Subject: ***Revised District Preliminary Geotechnical Report
I-10 Corridor Project, Los Angeles/San Bernardino Counties, California
07-LA-10 PM 44.9/48.3, 08-SBd-10 PM 0.0/R37.0, EA 0C2500***

**REVISED DISTRICT PRELIMINARY GEOTECHNICAL REPORT
I-10 CORRIDOR PROJECT
LOS ANGELES/SAN BERNARDINO COUNTIES, CALIFORNIA
07-LA-10 PM 44.9/48.3, 08-SBd-10 PM 0.0/R37.0, EA 0C2500**

- Appendix A. DPGR, Dated January 12, 2009, Prepared by EMI for I-10 HOV Project and Caltrans Approval Letter
- Appendix B. Caltrans Review Comments and EMI Responses
- Appendix C. Seismically-Induced Settlement Estimates

RECORDED EARTHQUAKE MAP

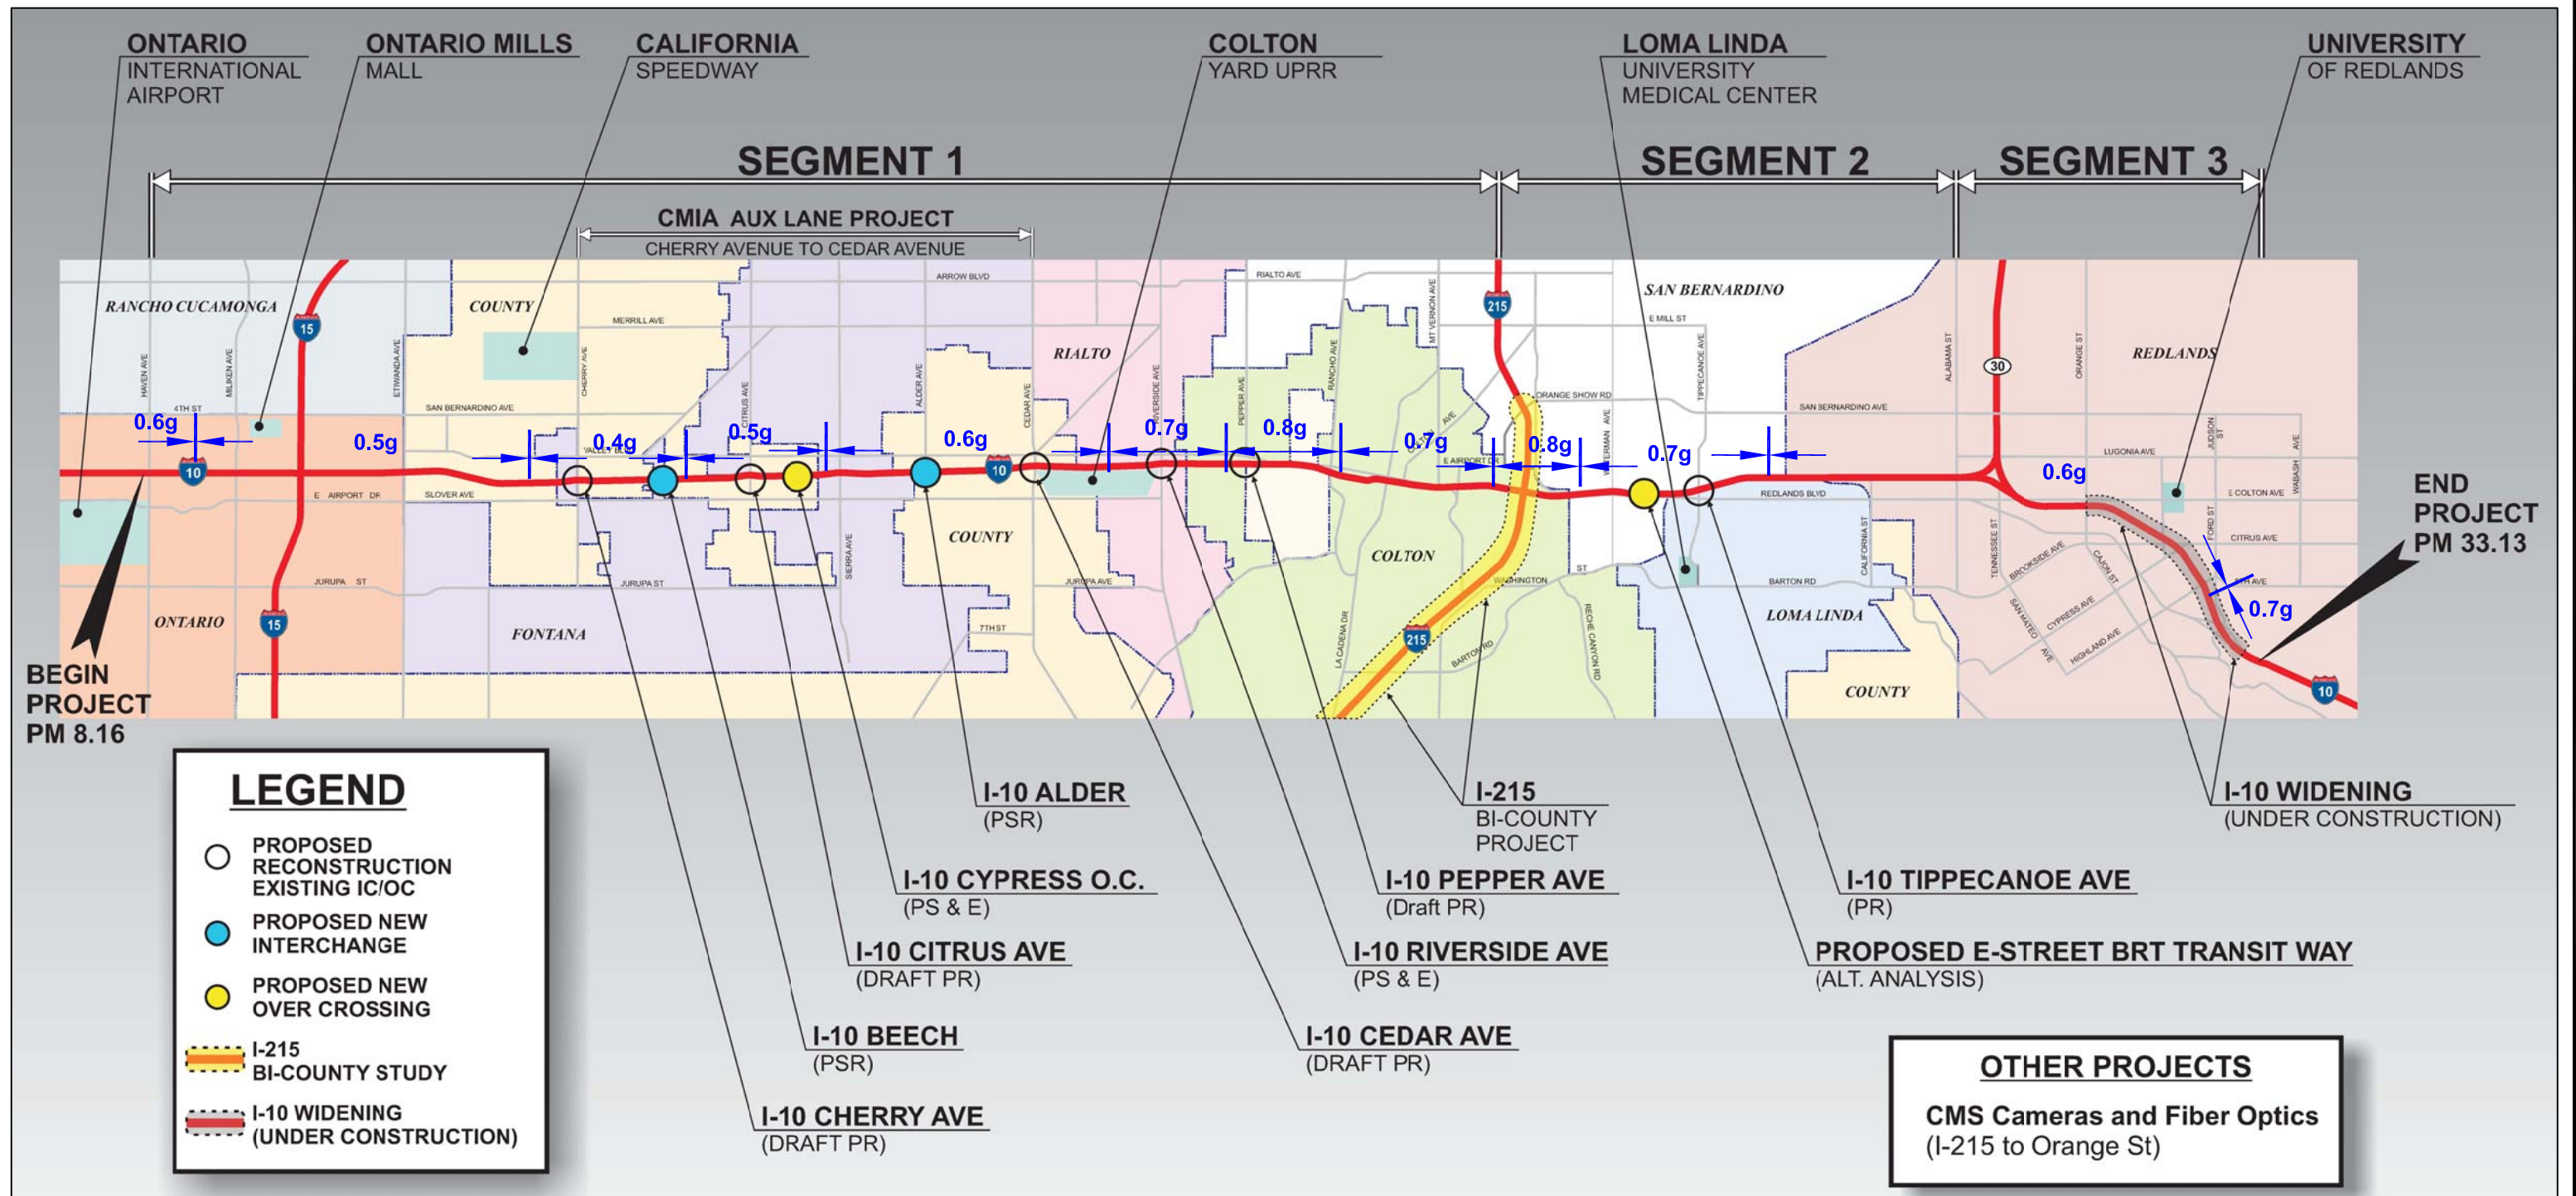
12	Page 6 Section 4.1 Seismicity	The descriptions of recorded earthquakes have been provided. Please show these records on a Seismicity map.	A seismicity map of instrumentally recorded earthquakes within the project region is provided in the attached Figure 1. The approximate locations of pre-instrumentally located events that occurred in the years of 1923 and 1899 are designated by circles with the numbers 23 and 99, respectively. Note that the report erroneously gave the date of the 1899 event as 1918. An instrumentally located event that occurred in 1998 near the junction of the San Jacinto fault and the Crafton Hills fault is also shown and designated by the number 98 within a circle.	CY	LC
